SEWAGE DISPOSAL SYSTEM

MARYLAND STATE DEPARTMENT OF HEALTH*

SUBDIVISION Heatherwood ROAD 1702 Heatherwood Way LOT 7

GRADING STUDY LOT 7
 HEATHERWOOD

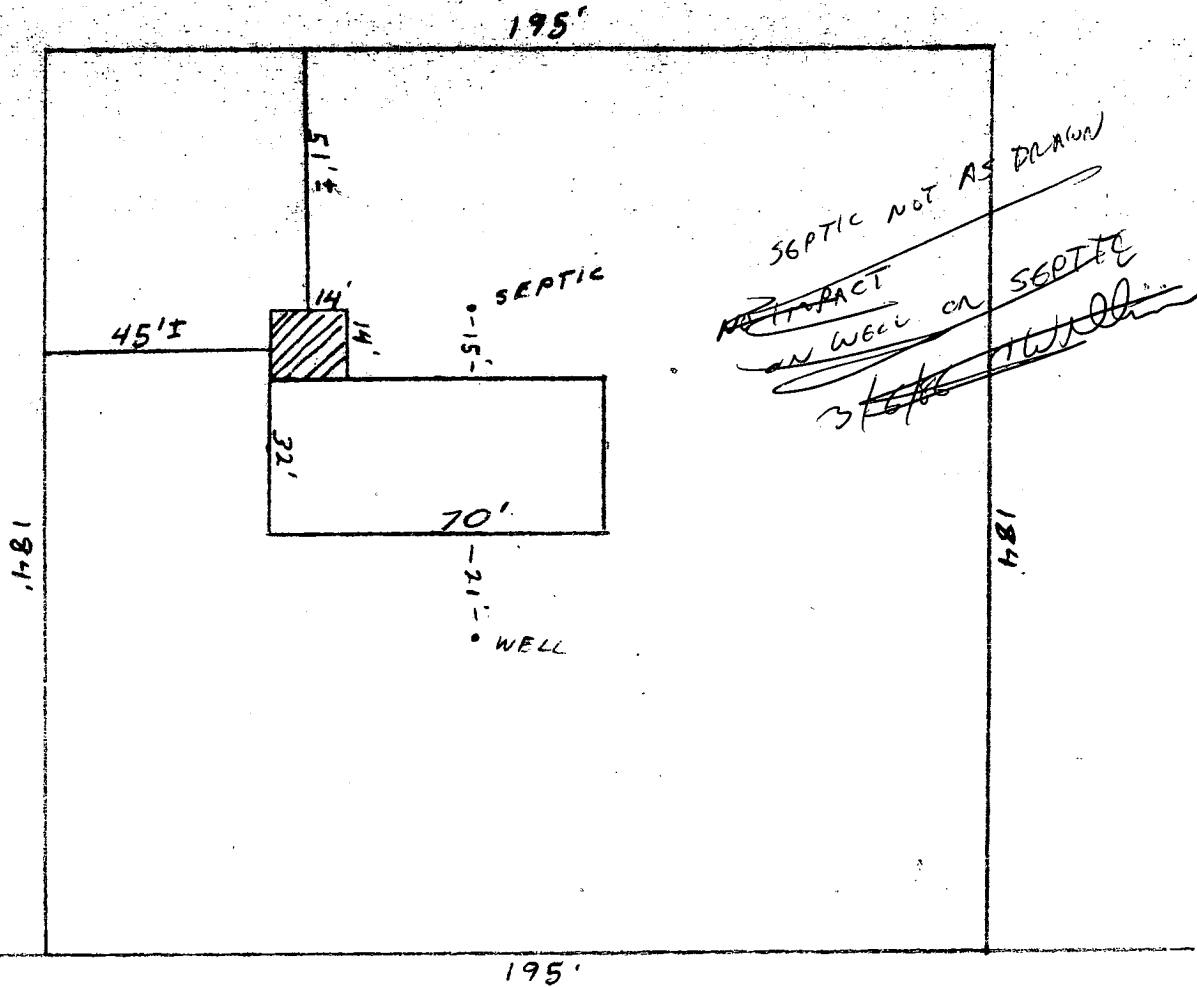
8/27/81 Trench may be 4ft wide x 90ft long F.S.

5/13/81
 Sketch O.K.
 F.S.
